Access Compliance Report

Public Rights-of-Way

(Curb Ramps)

Intersection ID: N/A	Main Street: ARBOR_LOOP_DR	Cross Street: ANSLEY_GARDEN_DR	Location: E
ADA ID: 7D612EF003ED	Ramp Type: Directional1	Initial Pass/Fail: Fail	Overall Compliance: No
Severity Score: 12.5			
Codes/Mitigation Info/Possible Solution		Field Measurements/Component Compliance

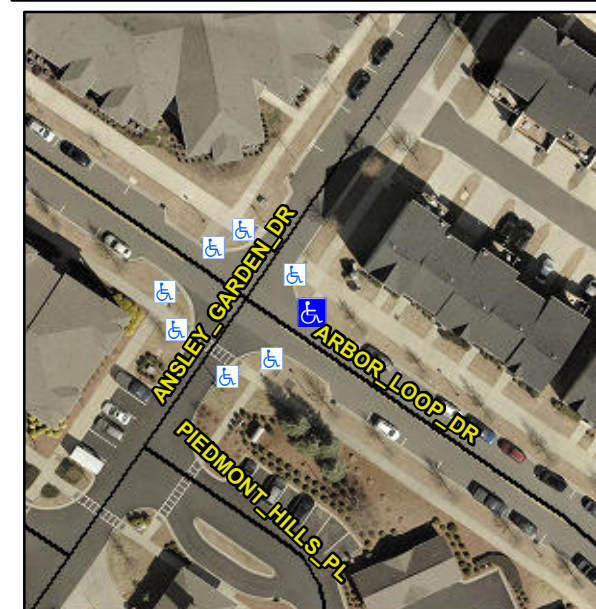
Compliance	Description	Data	Compliance	Description	Data
N/A	Ramp Length (in)	77.0	N/A	Grade Break?	N/A
Yes	Ramp Width (in)	58.0	N/A	Grade Break Slope (%)	0.0
No	Ramp Slope (%)	9.2	N/A	Grade Break XSlope (%)	0.0
Yes	Ramp XSlope (%)	0.3			
N/A	Flare Type LT	N/A	N/A	Flare Type RT	N/A
N/A	Flare Slope LT (%)	N/A	N/A	Flare Slope RT (%)	0.0
N/A	Flare Traversable LT?	N/A	N/A	Flare Traversable RT?	N/A
N/A	Landing Length (in)	0.0	N/A	DWS Provided?	N/A
N/A	Landing Width (in)	0.0	N/A	DWS Contrast?	N/A
N/A	Landing Slope (%)	0.0	N/A	DWS Length (in)	N/A
N/A	Landing X Slope (%)	0.0	N/A	DWS Full Width?	N/A
N/A	Landing Curb? (Y/N)	N/A	N/A	DWS Offset LT (in)	N/A
N/A	Shared Landing?	N/A	N/A	DWS Offset RT (in)	N/A
N/A	Gutter Ponding?	0.0	N/A	Gutter Slope (%)	N/A
N/A	Gutter Lip Ht (in)	0.0	N/A	Gutter X Slope (%)	N/A
N/A	Painted X Walk1?	No		Road Slope (%)	2.4
	X Walk 1 Direction	To SW		Road X Slope (%)	1.6
	X Walk 1 Width (in)	N/A		Clear Space?	N/A

Remove & Replace Entire Ramp.
